**DOCKET ITEM #10****Development Special Use Permit #2014-0041****Special Use Permit SUP #2014-0041****1801 Russell Rd – Immanuel Lutheran Church & School**

Purpose of Application

DSUP2014-0041
1801, 1809 Russell Road &
109, 111, 113 Belleaire Road

Figure 1 (Section IV.A. Conformance to Small Area Plan, Building Heights): This building elevation shows the profile of the church and school, as it would be viewed from Bellaire Road, looking north. Areas shaded in orange are the proposed buildings' addition/expansion.

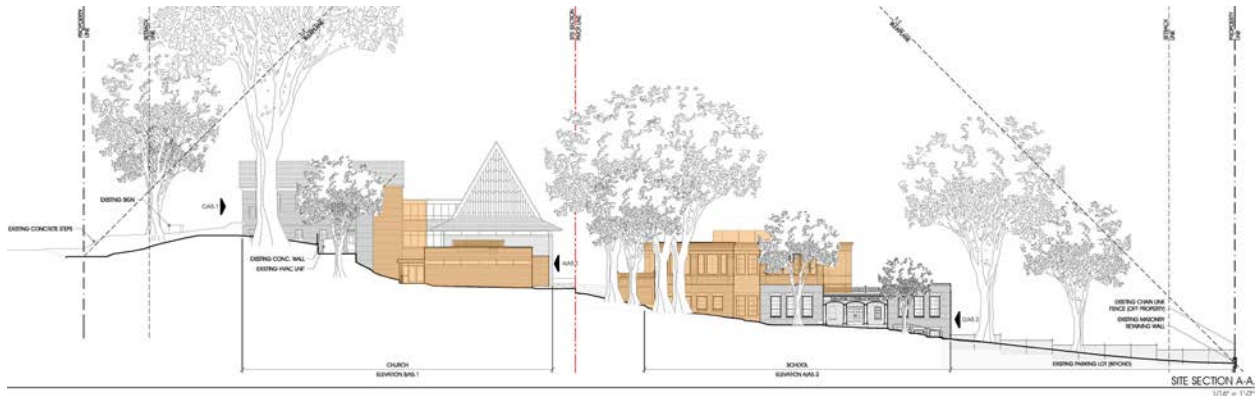
One of the plan's objectives is to restrict overall heights to reflect the low scale character of the area; the proposed improvements and expansion at Immanuel Lutheran are in line with this objective. The proposed church expansion is not as tall as the existing church and will not affect the overall massing of the church building. The proposed two-story school addition (with one-story below) will be set adjacent to the existing school building, on its west side. Because the site slopes from the west to the east, with the high point near the intersection of Russell Road and Bellaire Road, the school's uppermost roof will be about 40 feet lower than the height of the existing sanctuary parapet. These considerations made in height and siting of structures help to maintain the existing "low scale residential character" addressed in the SAP.
